Supercell and module assembly for ProtoDUNE run 2 @ Milano-Bicocca: lessons learned

C. Brizzolari, C. Cattadori, C. Massari, L. Meazza
14/11/2022

Mechanical and assembly issues of the single SC

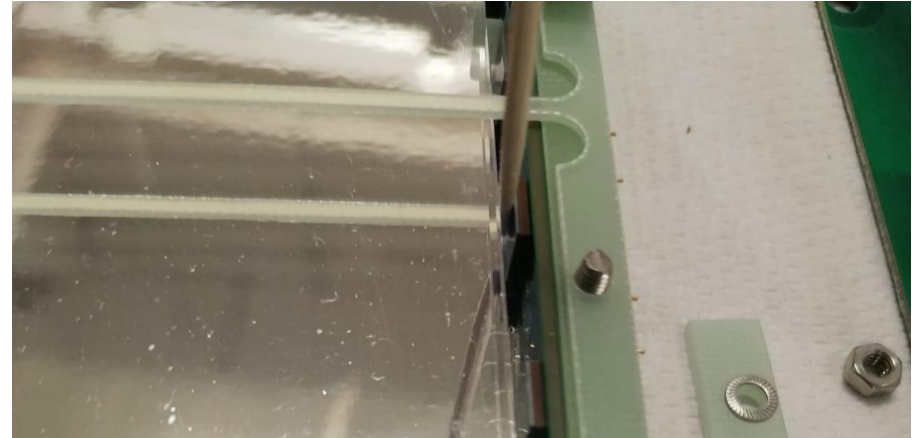
G10 pieces: 42

Screws: 48 (of 4 types)

Washers: 12-20

Nuts: 12

**Total: 114-122 → ~ 1:30/2:00 h of assembly
(if the operator is fast and the Vikuiti is
already in place, else ~3 h)**

Vikuiti: 60 stickers, 2 big and 58 small

Main Recommendation: Drastically Reduce ($\frac{1}{2}$ - $\frac{1}{3}$) the overall number of G10 pieces and screws/fasteners

1. A single frame or 2 long pieces to hold the dichroics instead of 10, less screws (from 24 to ???);
2. Threaded holes to avoid the 12 nuts and 12 washers;
3. No SiPM spacer blocks (no need);
4. WLS bar dimensions revisited, in order to have optical contact at least a room temperature and smaller gap at cold;
5. 2 long G10 pieces instead of 8 for the SiPMs motherboards (SMBs);
6. If still possible,
 - a. back spring loading of SiPMs against WLS bars;
 - b. reduce number of pins on SMBs (easier Routing Boards plugging);
 - c. increase pins diameter (less fragile)

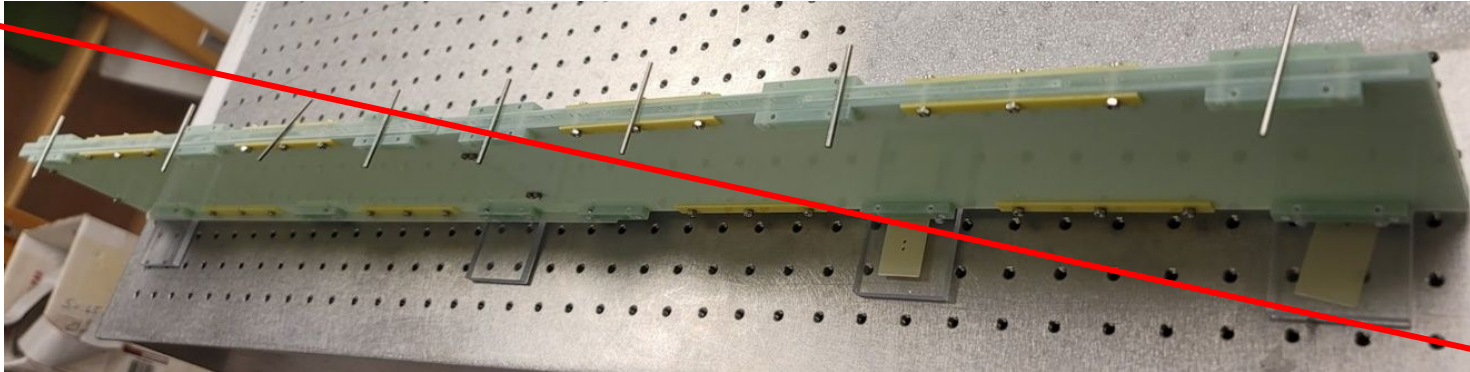
At least **1 mm gap at room temperature** between G2P WLS bar and HPK SiPMs → **it increases at cold (~2 mm).**

Shrinking of G2P WLS bar: 8.3‰ (lower limit).

Shrinking of the frame: with our method it wasn't observable/measurable.

Mechanical and assembly issues of the full module and proposed solutions

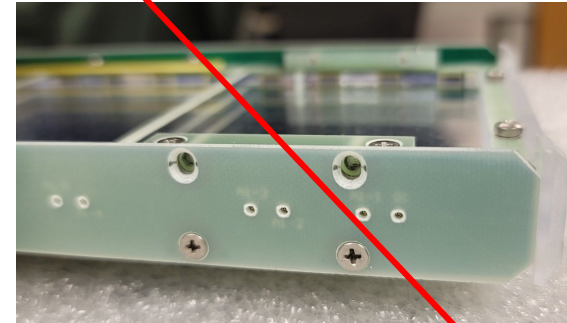
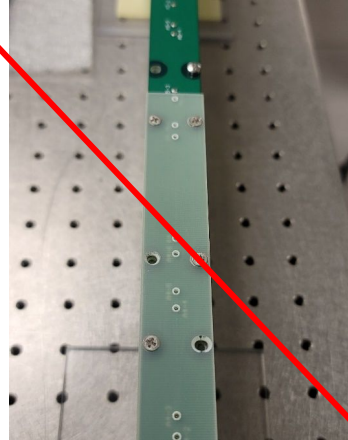
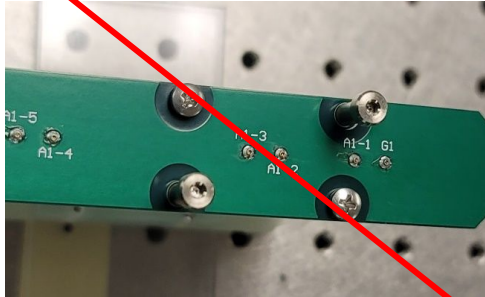
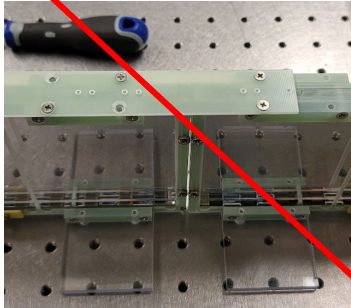
- Full module assembly procedure (as described in the module assembly procedure document, rev. 28 April 2022 → ~1 day, ~5 people, one module assembled) to be heavily revised:
 - No need to screw ALL the screws of the RBs for each passage (in the procedure document routing boards screws were screwed and unscrewed no less than 7 times)
